INSTALLATION OF 075-17600 TORQUE PLATE SUBASSEMBLY AND 159-03500 DISCS IN PARKER 30-161 BRAKE ASSEMBLY

EFFECTIVITY: All 30-161 brakes that are not to the 30-161A configuration.

REASON: This bulletin provides a procedure for the installation of the 075-17600 Torque Plate Subassembly and 159-03500 Discs in the 30-161 Brake Assembly in place of the 065-15300 Torque Tube, 074-05400 Back Plate Assembly and 159-01300 Discs. This bulletin will allow for the field installation of the Torque Plate Subassembly (P/N 075-17600) and Discs (P/N 159-03500) on a Cessna Model S550 aircraft for the purpose of improving wear and performance.

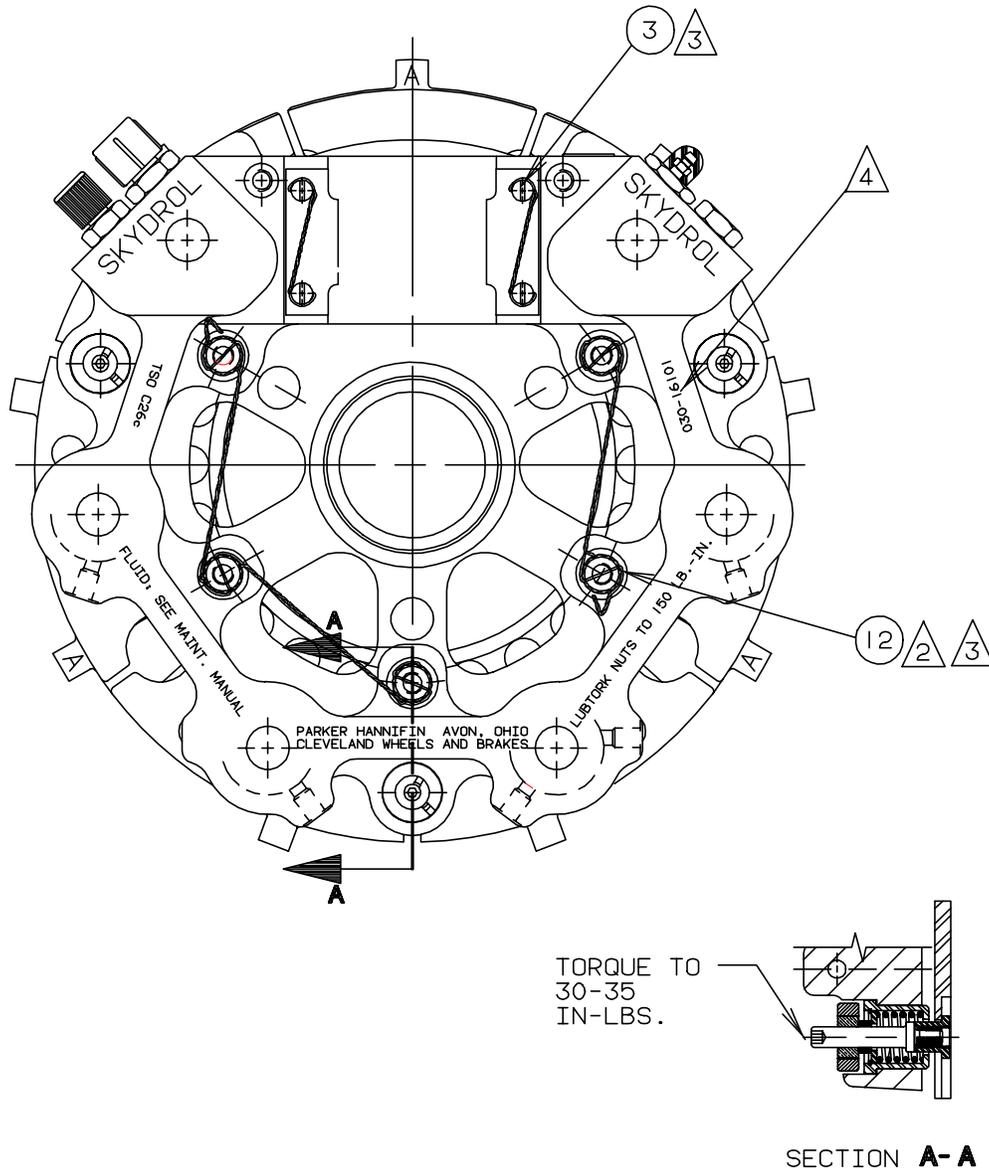
- A. Place brake assembly on a clean, flat work surface.
- B. Remove and discard five (5) self-locking nuts (094-13200), washers (095-13600), bolts (103-22801) and washers (095-02801).
- C. Remove and discard 074-05400 Backplate Assembly, 065-15300 Torque Tube and 159-01300 Discs.
- D. Remove and retain one (1) Center Stator Assembly (P/N 242-00700).

- A. Install Disc (P/N 159-03500), Center Stator Assembly (P/N 242-00700), and Disc (P/N 159-03500) onto 075-17600 Torque Plate Subassembly keeping the wear surfaces oriented as they were on the 065-15300 Torque Tube when removed.

- B. Install Cylinder Assembly (with pressure plate attached) onto the 075-17600 Torque Plate Subassembly, aligning holes with the tapped holes on the lugs of the Torque Plate.

- C. Next, place 095-02800 washer onto the 103-85300 bolt and apply MIL-T-5544B anti-seize compound to both surfaces of washer, under bolt head and threads of bolt. When installing washer onto bolt, the countersink on the washer must face bolt head or bolt failure may result.

- D. Install five (5) 103-85300 bolts thru cylinder into torque plate subassembly, snug down and then final torque to 150 lb.-in and safety wire with MS20995C32 per MS33540.

- E. Test brake in accordance with "Testing Procedure", page 701 of 30-161A Overhaul Manual.
- F. Re-identify brake assembly with new nameplate 166-10800 as follows:

- Model - 30-161A
 - Date Manufactured - (Enter date of manufacture off old nameplate)
 - Serial Number - (Enter serial number of brake assembly)
 - Weight - 35.8#
